FINAL DRAFT 17 MAY 2022

# Draft Campsie Master Plan Site Specific Review

Joint Panel Report

Figure 43: Site C6 Height (in storeys)

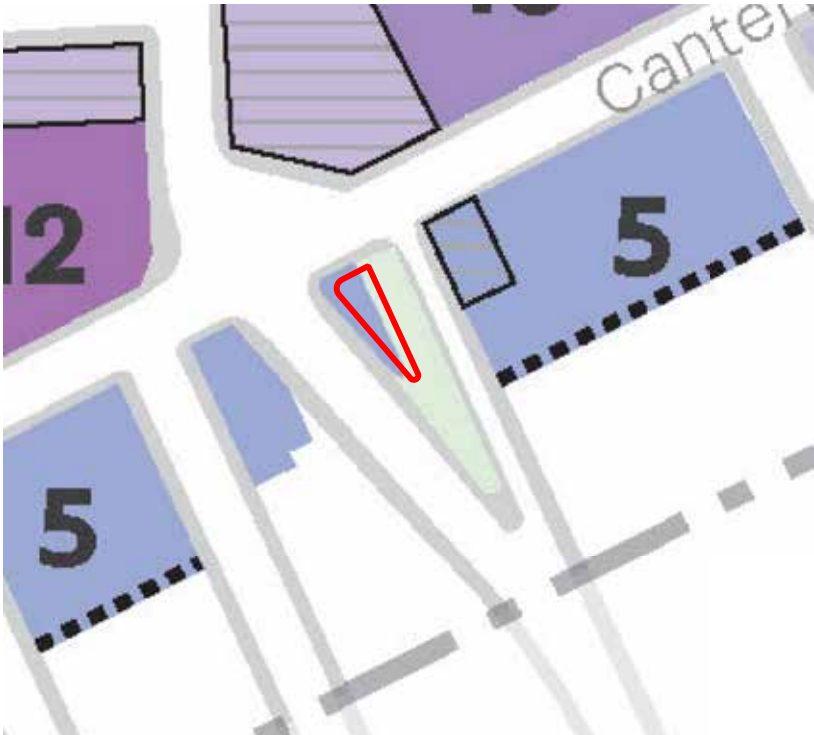
The use of the site as part of a redevelopment is therefore not supported and the Panel considers that the privately owned (173m<sup>2</sup>) portion of the site is not big enough to support a viable development outcome, nor the proposed variations to the draft Master Plan.

The draft Master Plan requires development on land in this location (and generally on the southern side of Canterbury Road) to be lower in height, to transition between taller future development to the north and lower existing development to the south. Whilst there is a logic to the proposed expression of this unusual island site with a taller building, the Panel considers the proposed height would detract from the consistent form and height transitions that the draft Master Plan is seeking to achieve.

- Maintain the existing B5 zoning.
- Maintain the existing draft Master Plan height, FSR and setback controls.
